PLAT COMMITTEE

June 12, 2024

Case Number:	2024-PLT-027
Property Address:	913 North LaSalle Street (<i>Approximate Address</i>)
Location:	Center Township, Council District #13
Petitioner:	Edmundson Estates LLC, by John Cross
Zoning:	D-5
Request:	Approval of a Subdivision Plat to be known as Edmundson's Replat of Lot 4, Block 11 in George F. Adams Subdivision, subdividing 0.155-acre into two single-family attached lots.
Waiver Requested:	None
Current Land Use:	Two-Family Dwelling
Staff Reviewer:	Noah Stern, Senior Planner

Preliminary Plat

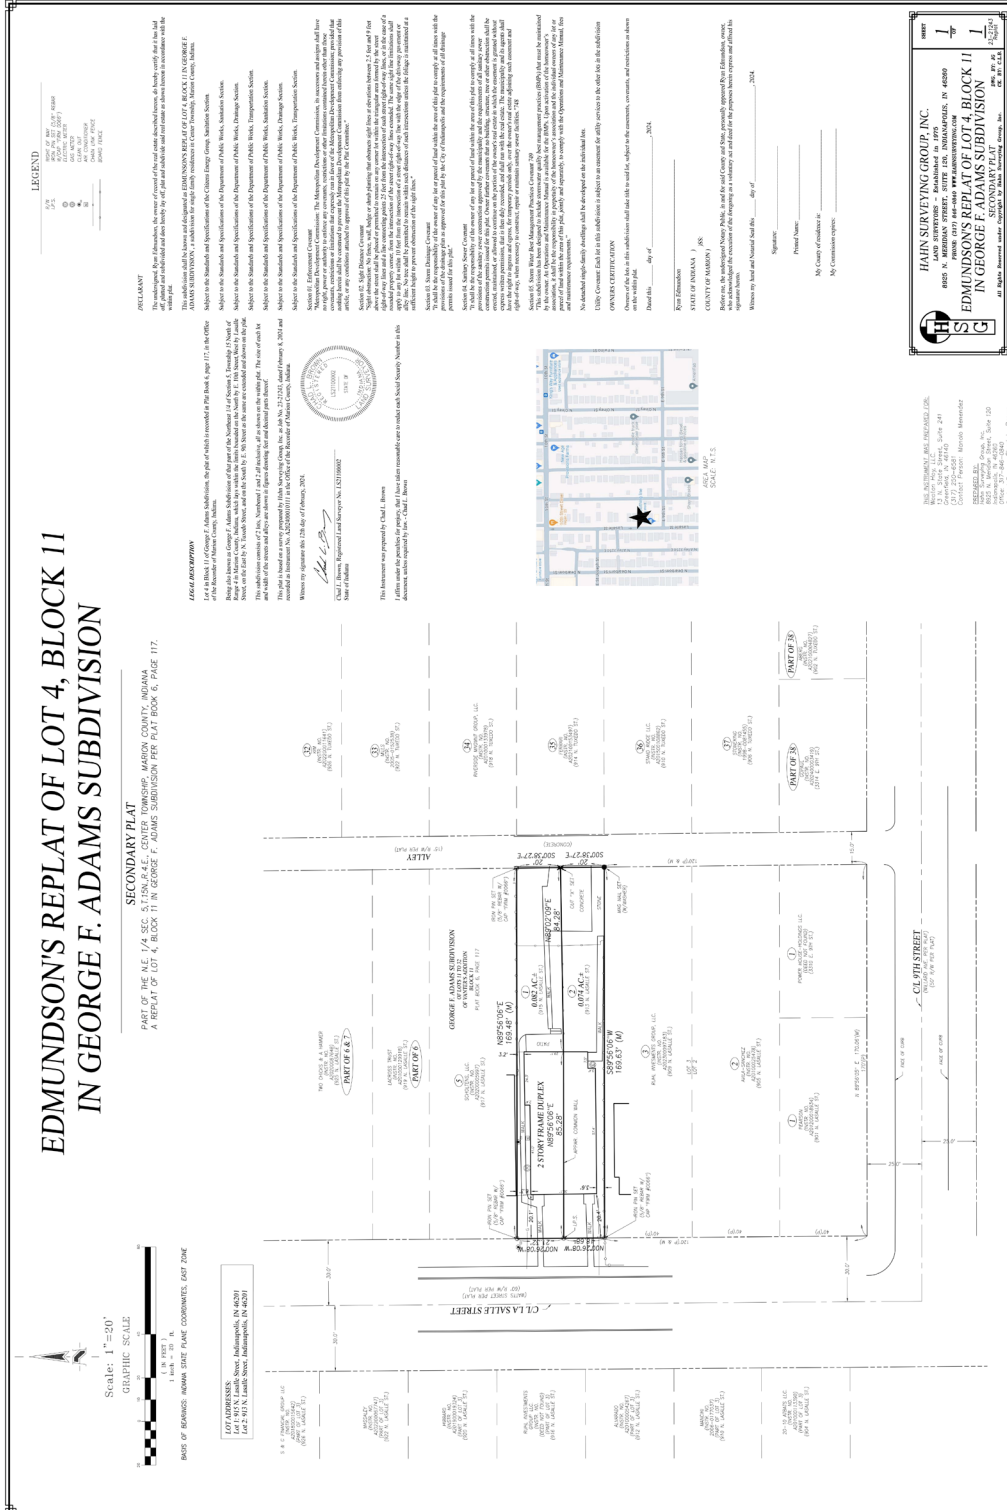
Staff recommends that the Plat Committee **approve** and find that the plat, file-dated April 11, 2024, complies with the standards of the Subdivision regulations, subject to the following conditions:

The subject site is zoned D-5 and developed with a two-family dwelling. This proposed plat would divide the existing parcel into two lots. The two lots would each contain half of the two-family dwelling with the lot line following the common wall and continuing through the rear of the lot. The subject site has been developed with a two-family dwelling since at least 1915, per the Sanborn map below. This replat would allow the property owner to sell each of the parcels individually, rather than as one parcel, with minimal impact on the surrounding property owners.
